Pad I – Waste Rock & Ore Stockpiles

TIA Observations

Doris TIA OMS

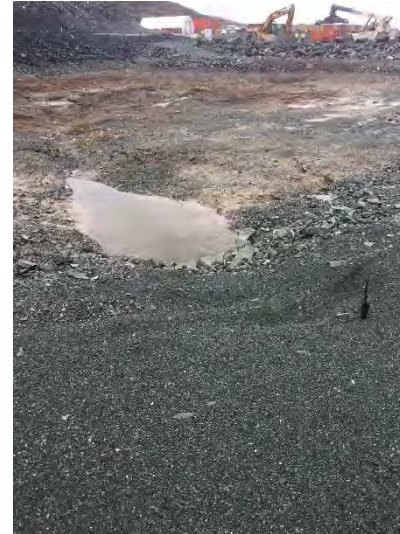
- Is DETOX tailings being stored on Waste Rock Pile?
- OK as long as it is tracked

★ Sedimentation Pond

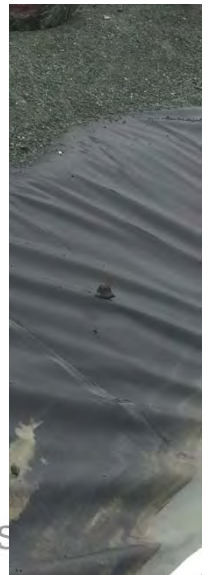
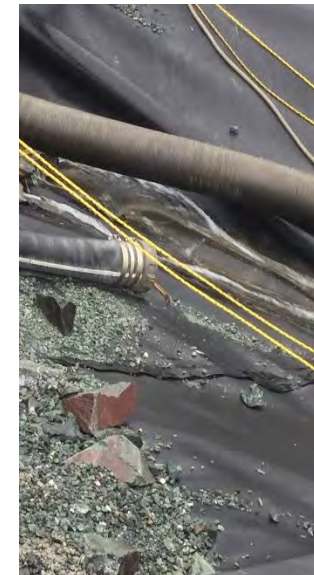
- Should do general cleanup of all rocks and gravel on liner slopes
- Fix the excavation on the south-west corner

Reagent Pad

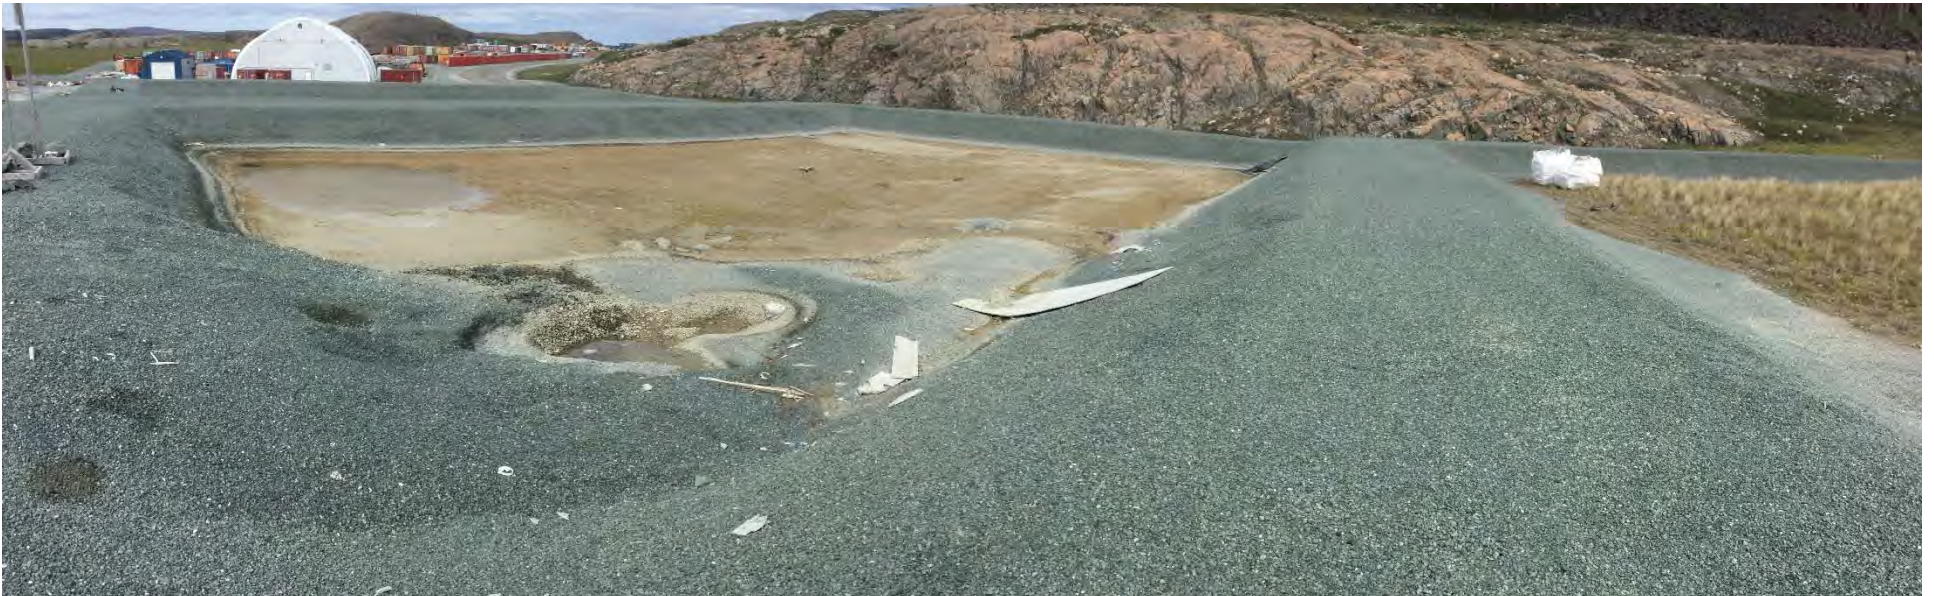
- Over steepened slope on north
- Exposed liner on south

North Dam Instrumentation

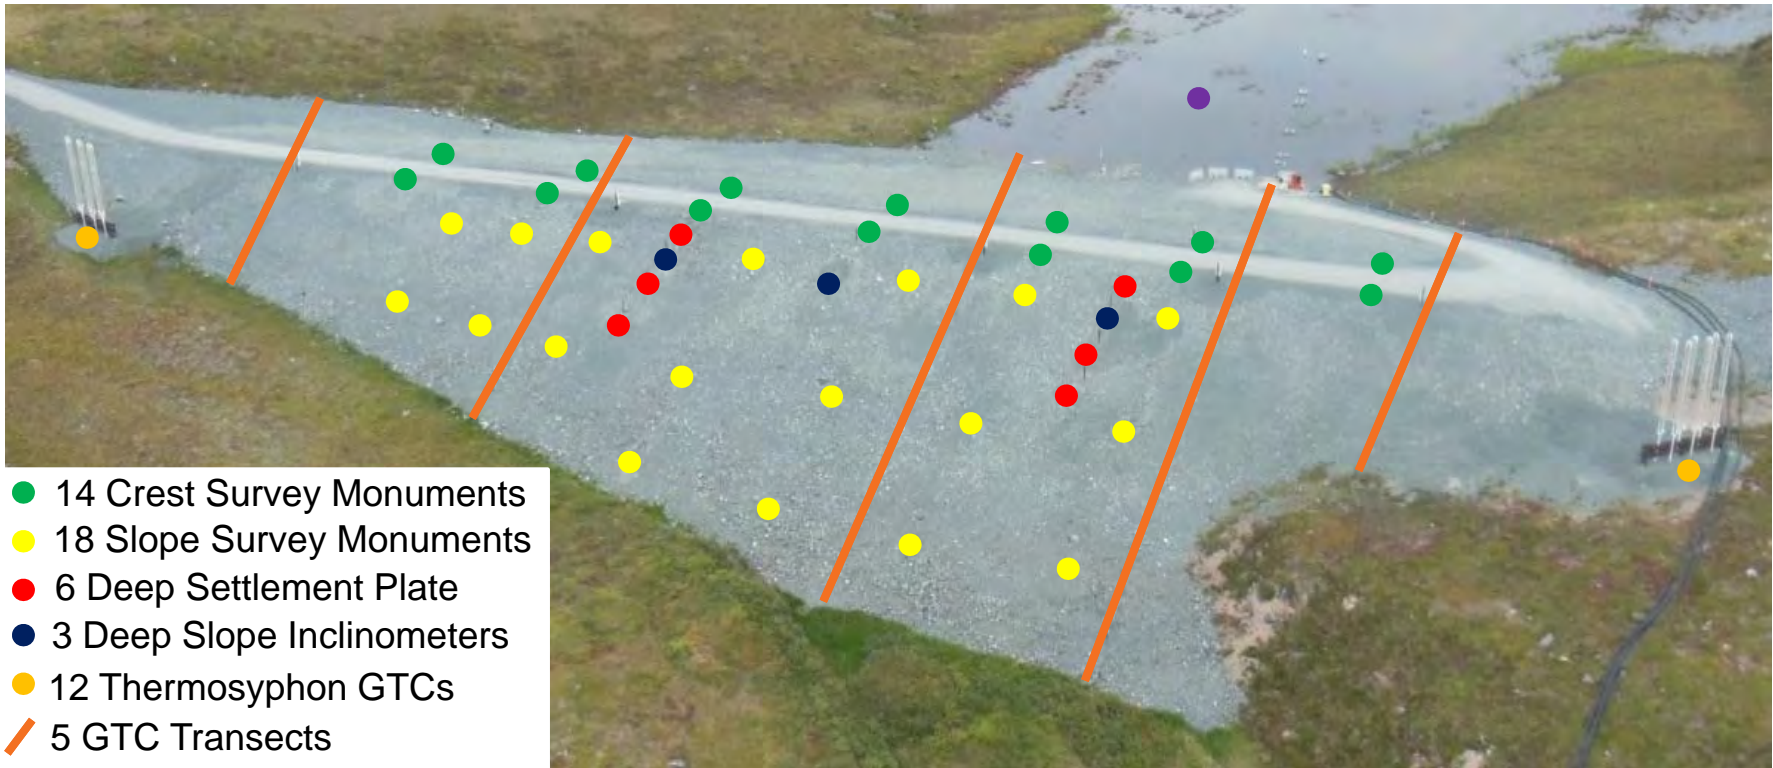
- Watch tension cracks on upstream slope near shoreline
- Backfill with crush around inclinometer housing of Station 0+130 m
- Replace bottom weatherproof housing for node D

South Dam Instrumentation

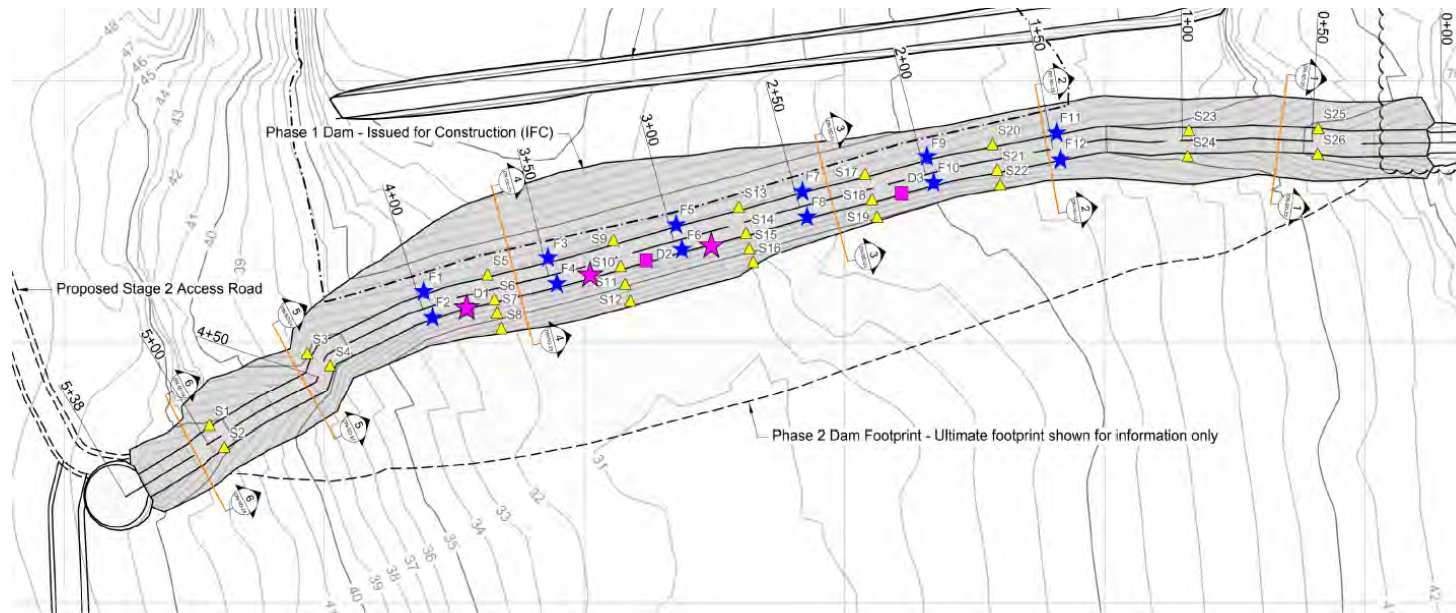
- Small construction completion tasks to final signoff
- Some instrumentation to be completed
- Monitoring SOP to be updated
- Watch for ponding at back of dam
- Start beach development immediately
